LOT 5, RIZVI PROPERTY
ON-SITE SEWAGE DISPOSAL SYSTEM DESIGN PLAN
14945 OLD FREDERICK ROAD
WOODBINE, MD 21797
TAX#: 348885, SUB: 1001

Approved Septic System Plan
Howard County Health Department

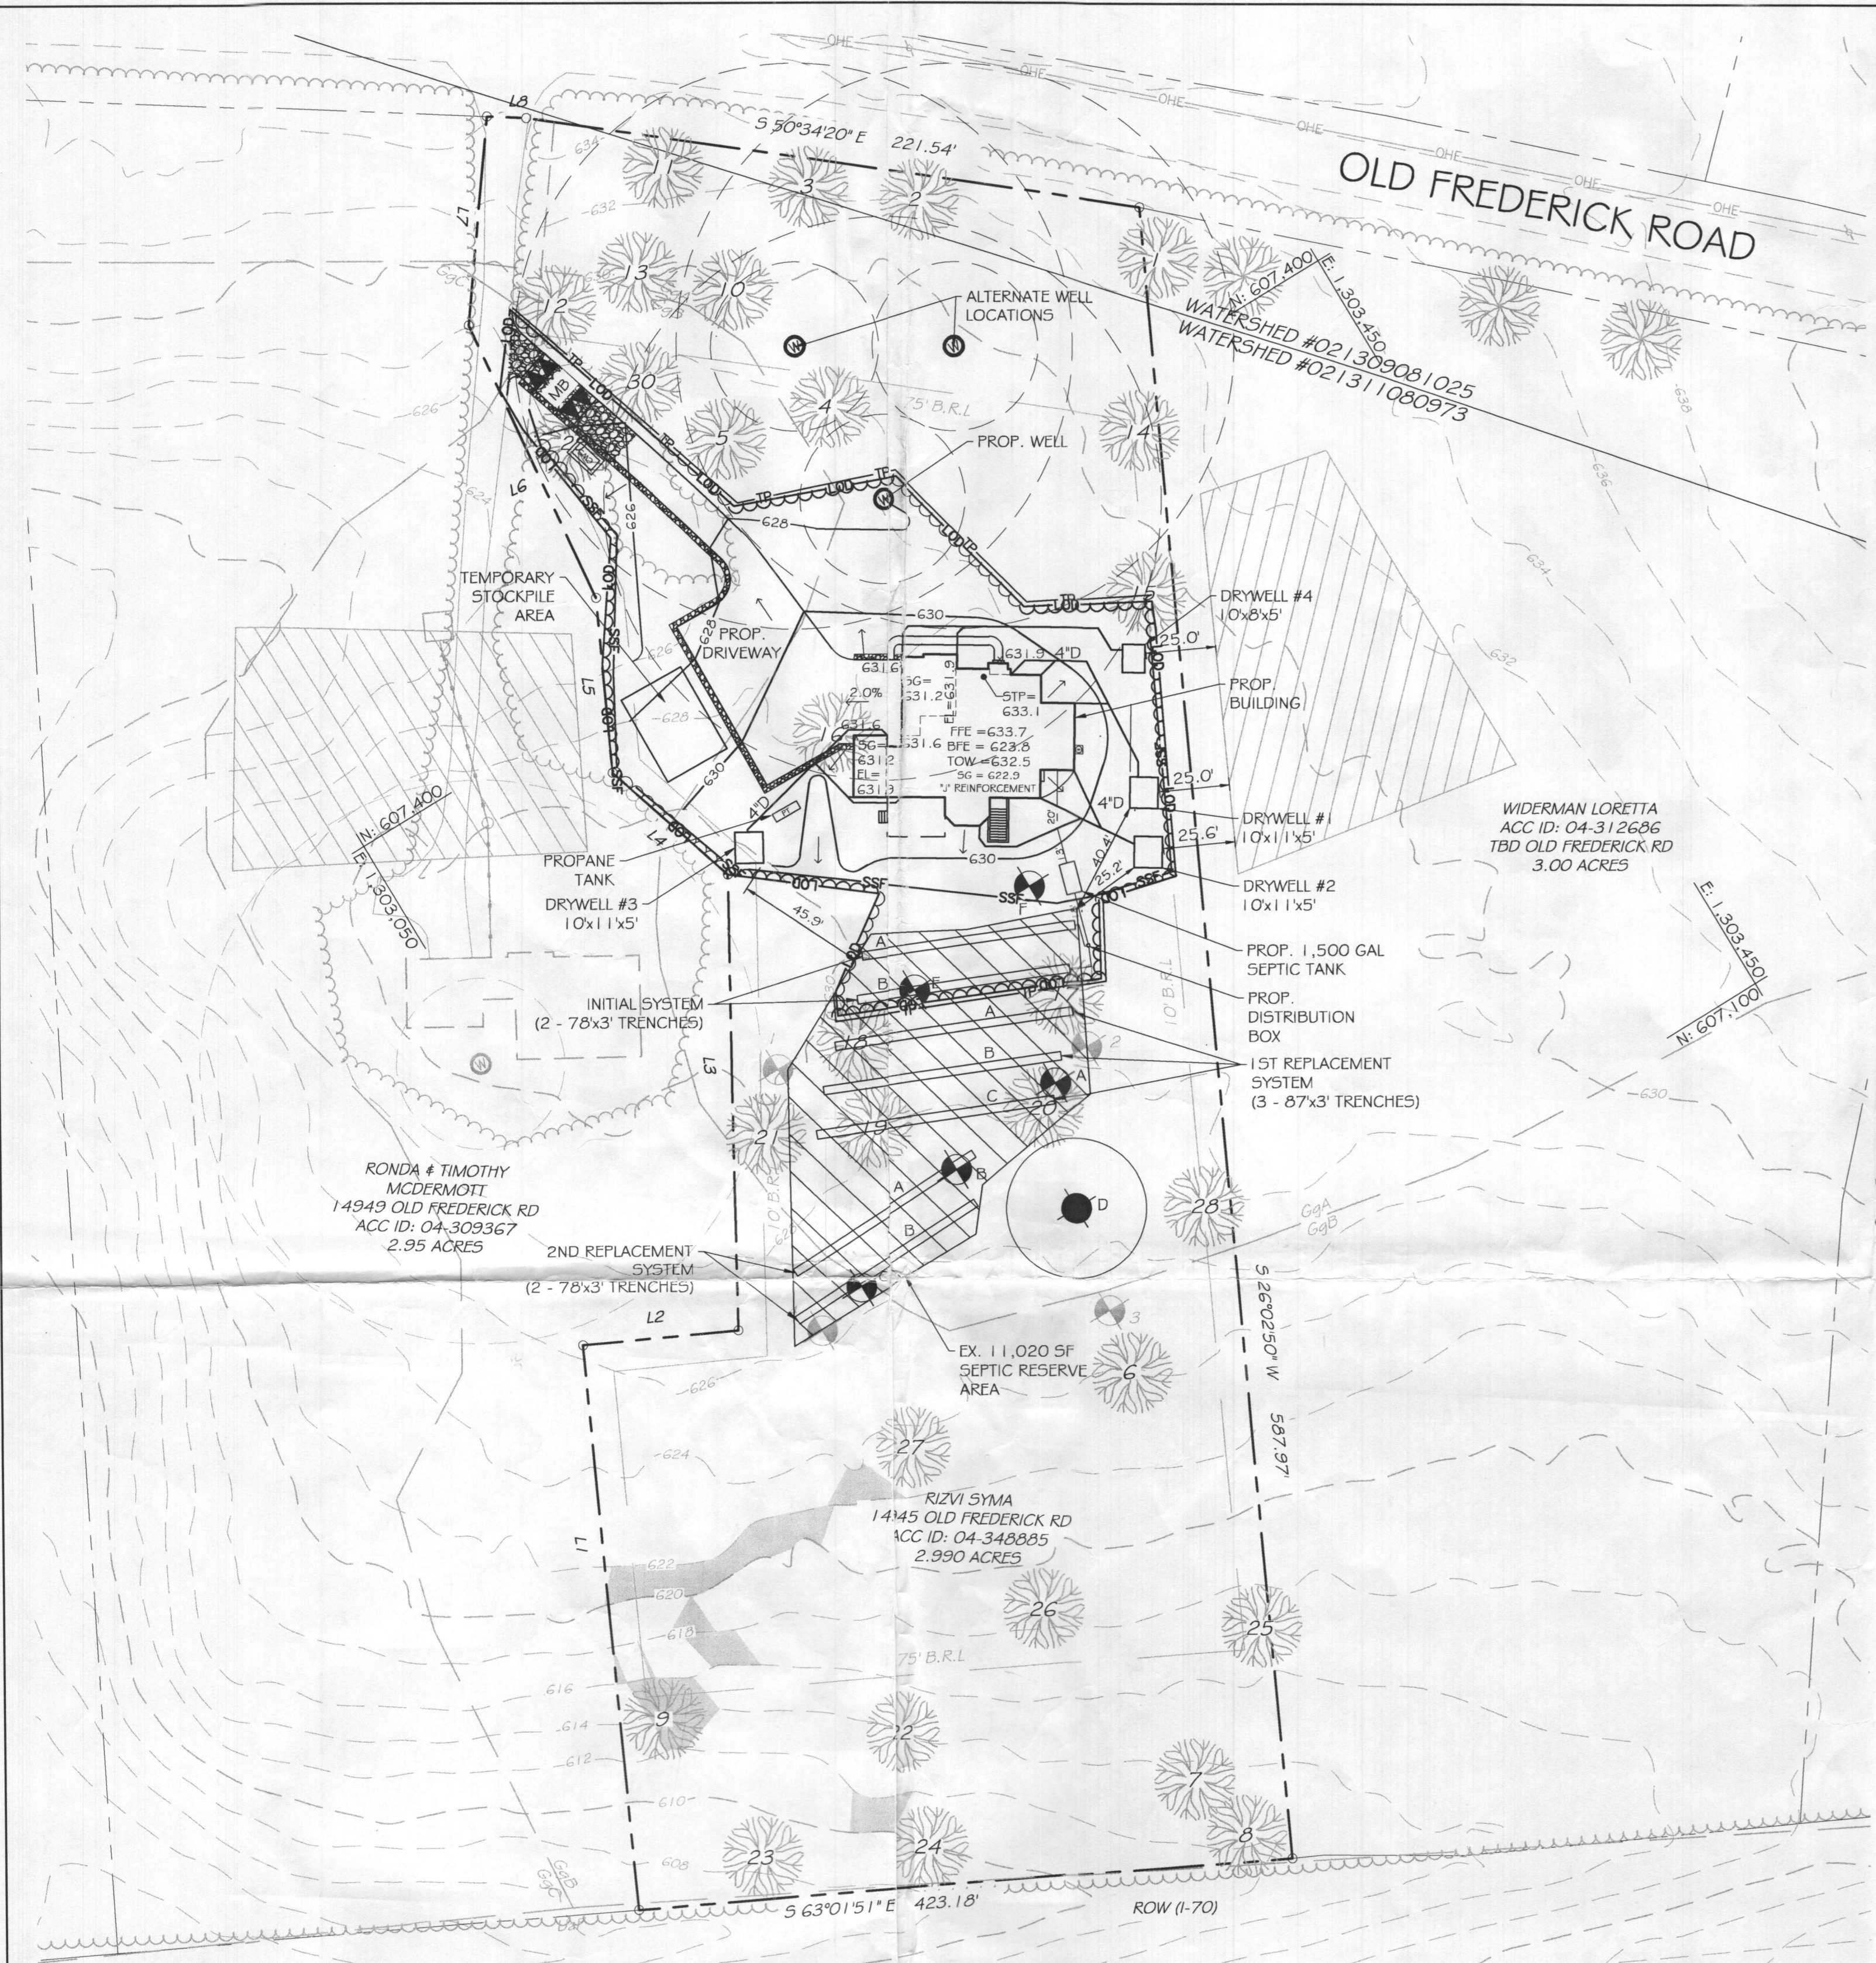
Revise.
3/8/13/22

LOT 5, RIZVI PROPERTY
ON-SITE SEWAGE DISPOSAL SYSTEM DESIGN PLAN
14945 OLD FREDERICK ROAD
WOODBINE, MD 21797
TAX#: 348885, SUB: 1001

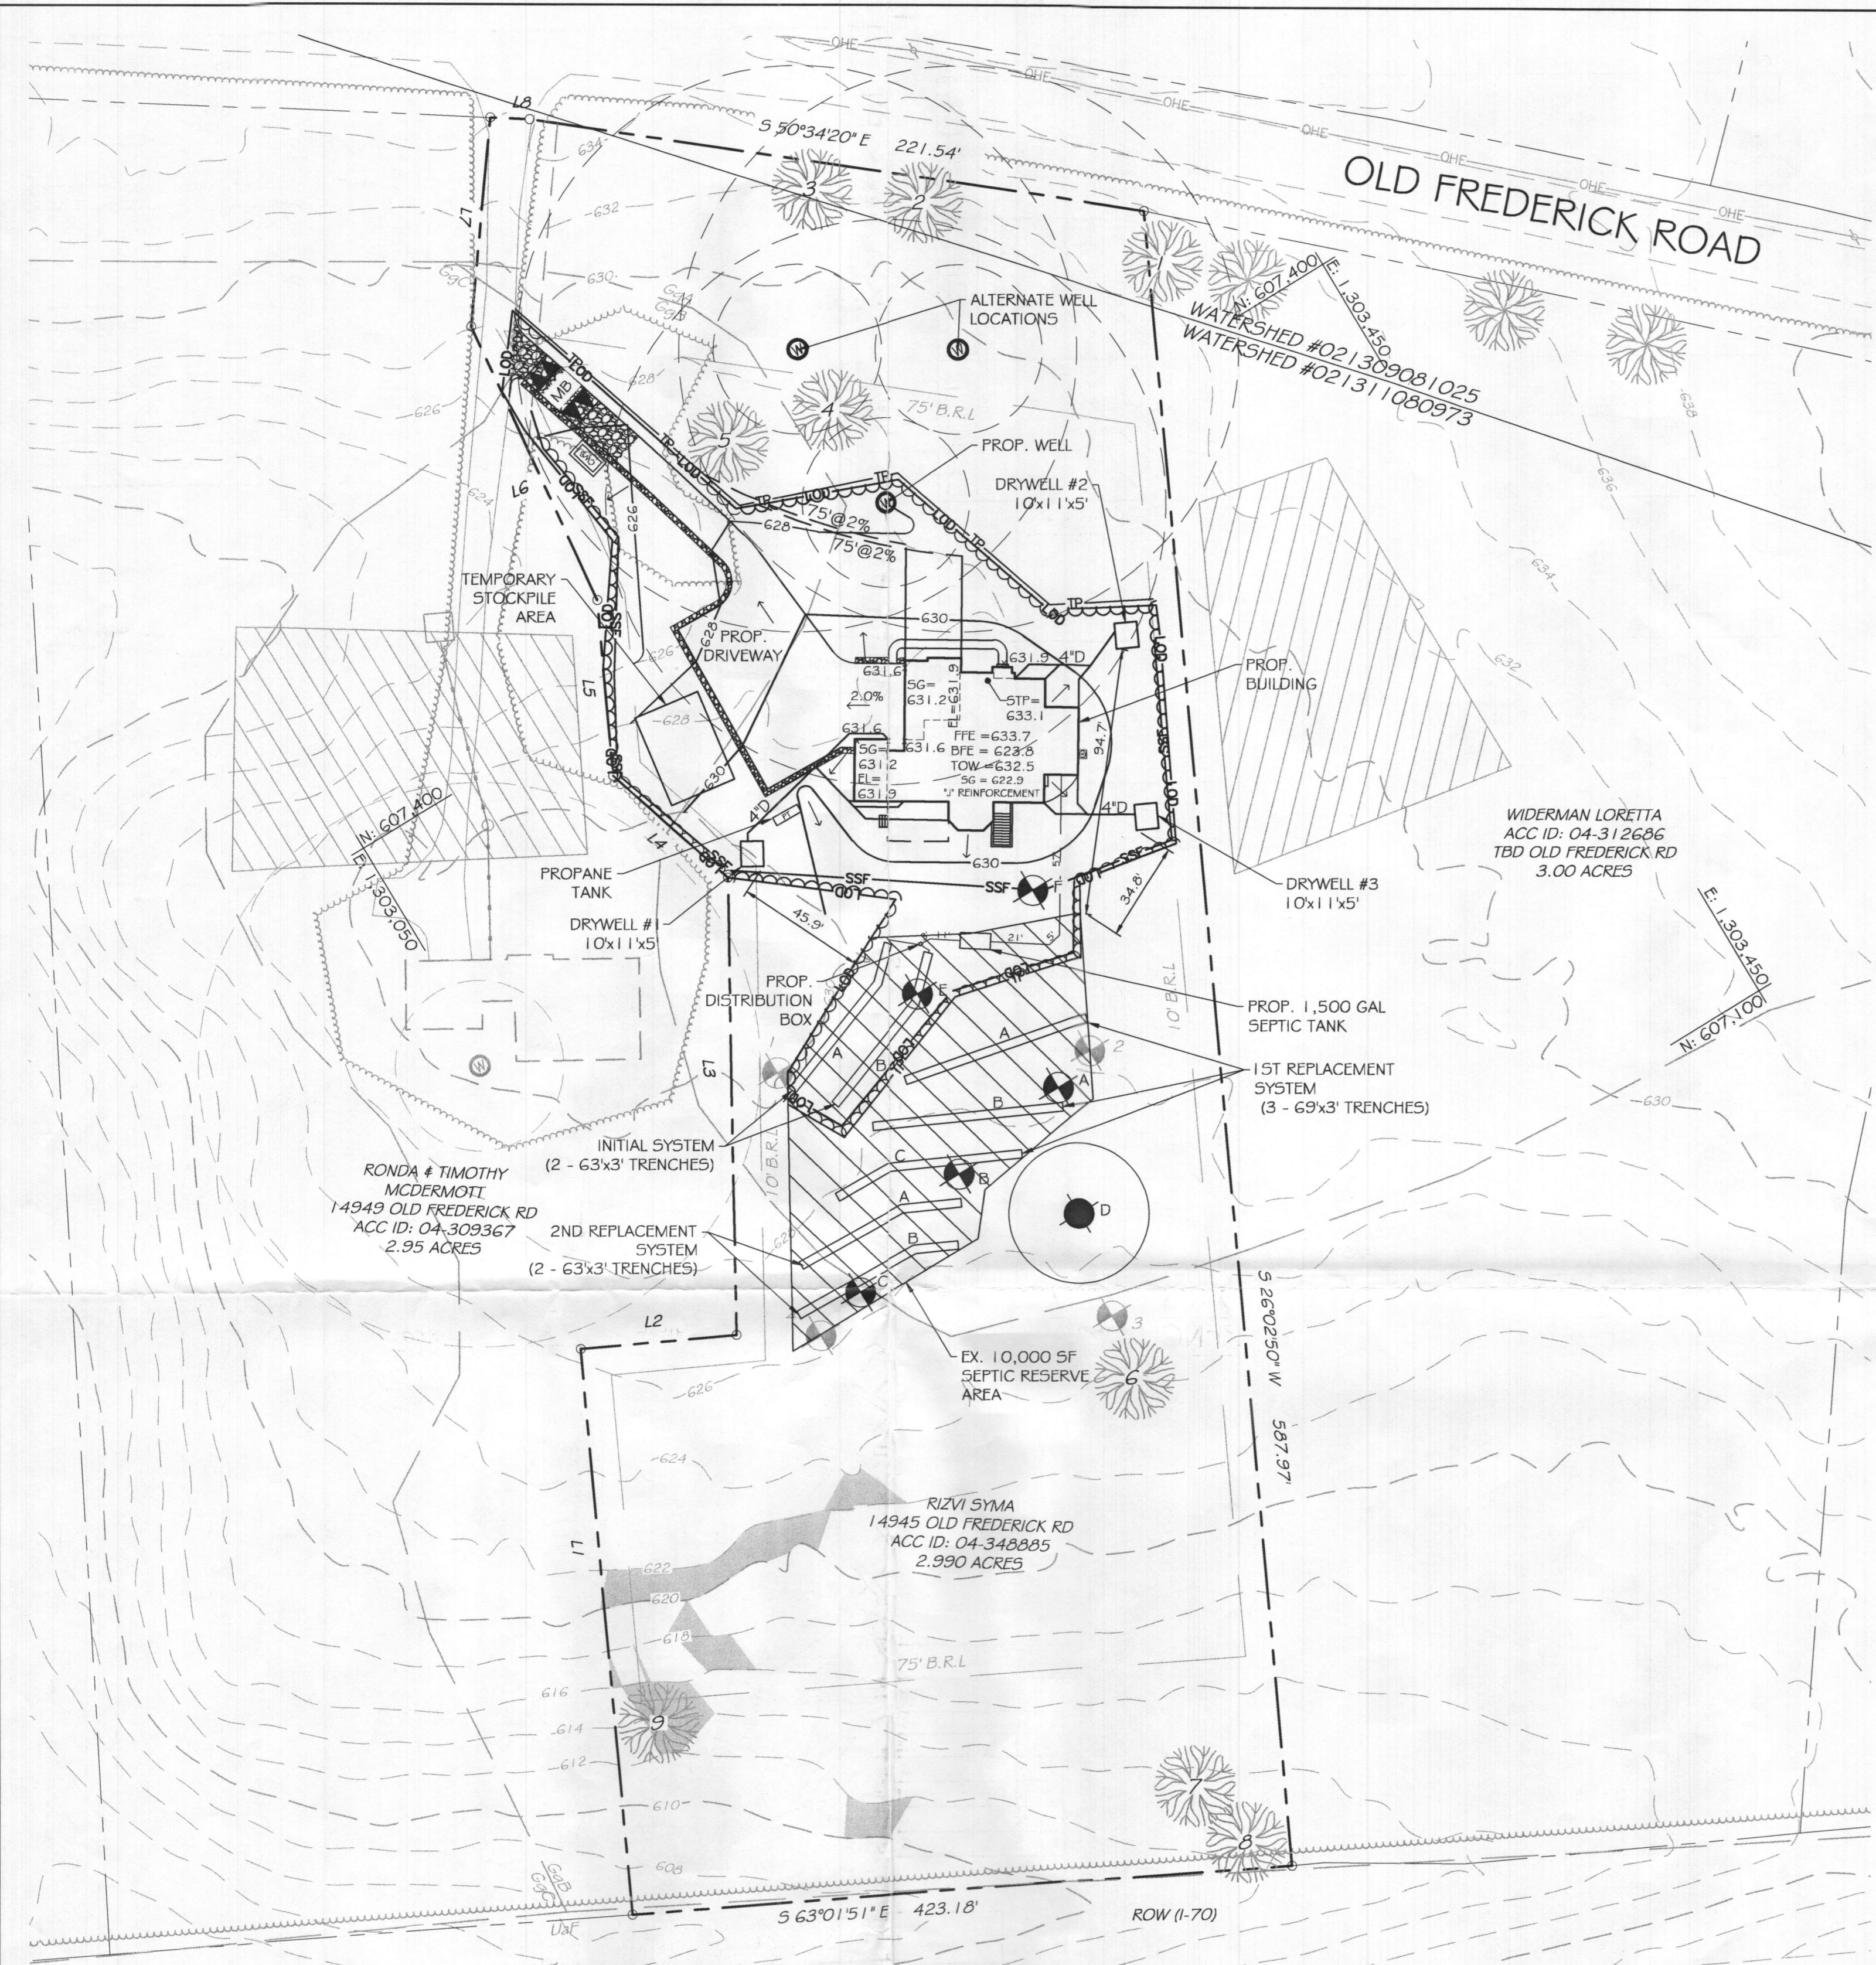
Revise
gjb 11/29/22

LOT 5, RIZVI PROPERTY
ON-SITE SEWAGE DISPOSAL SYSTEM DESIGN PLAN
14945 OLD FREDERICK ROAD
WOODBINE, MD 21797
TAX#: 348885, SUB: 1001

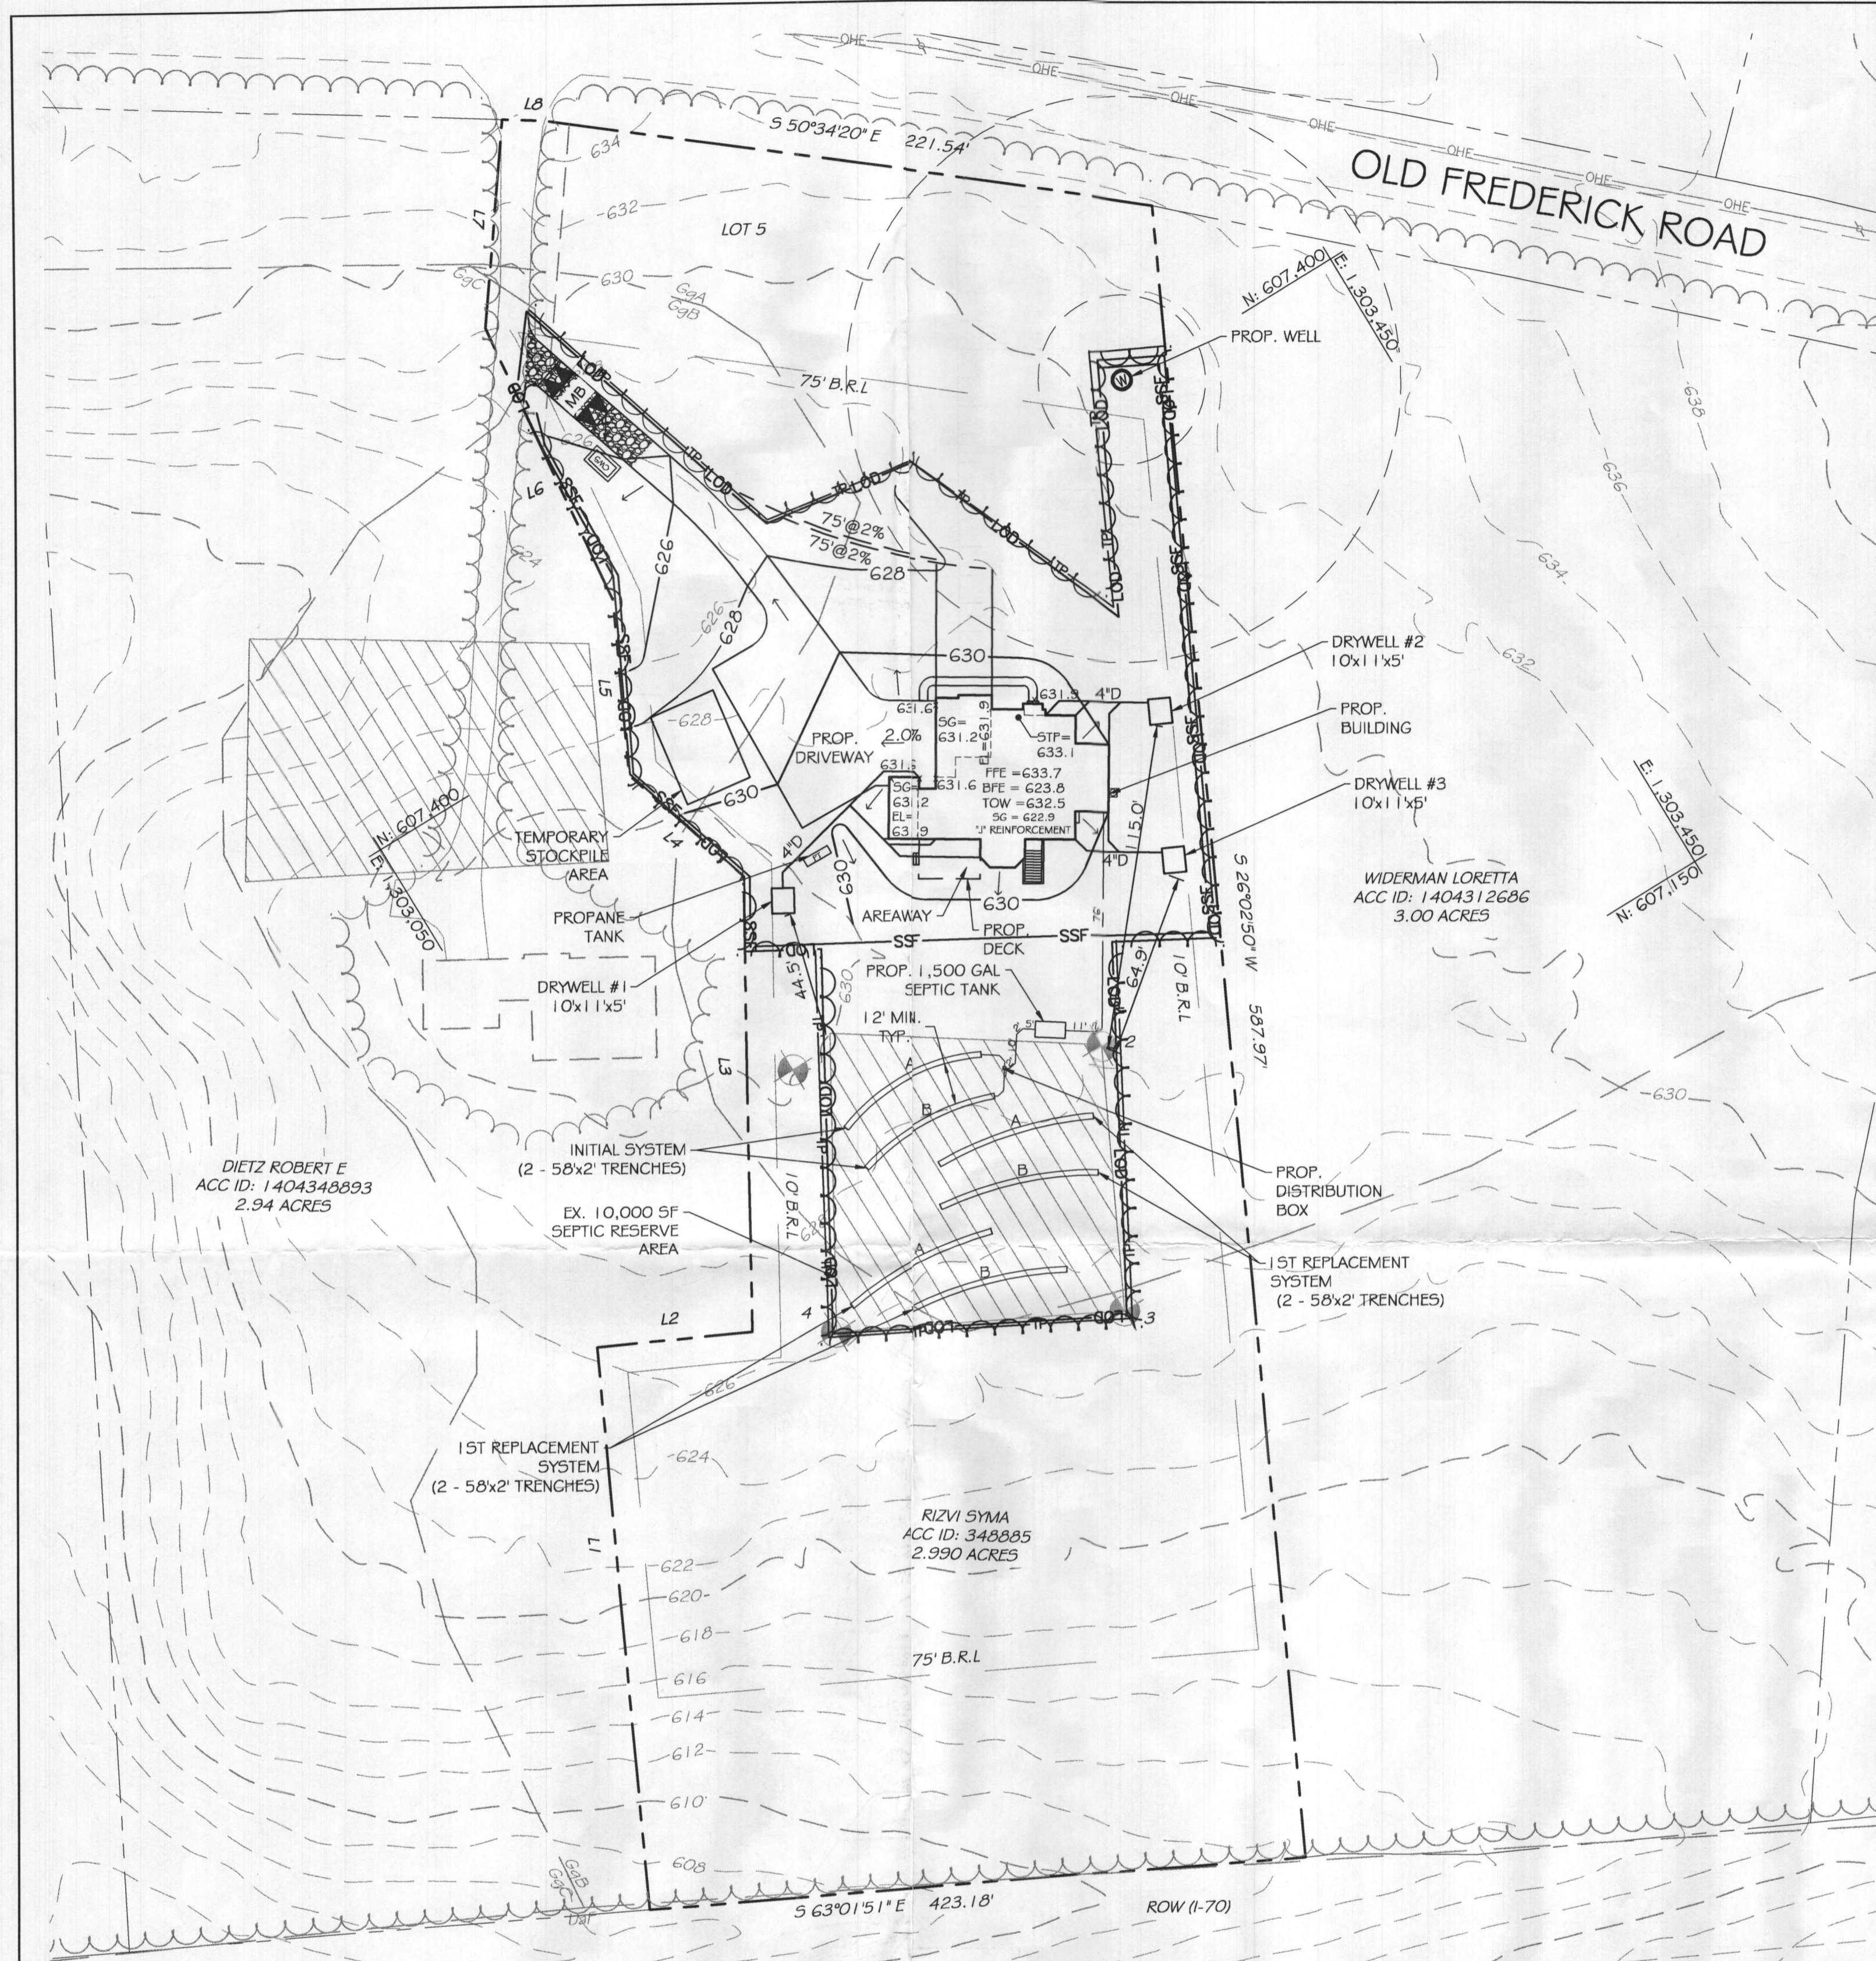
Revise.
gjb 11/29/22
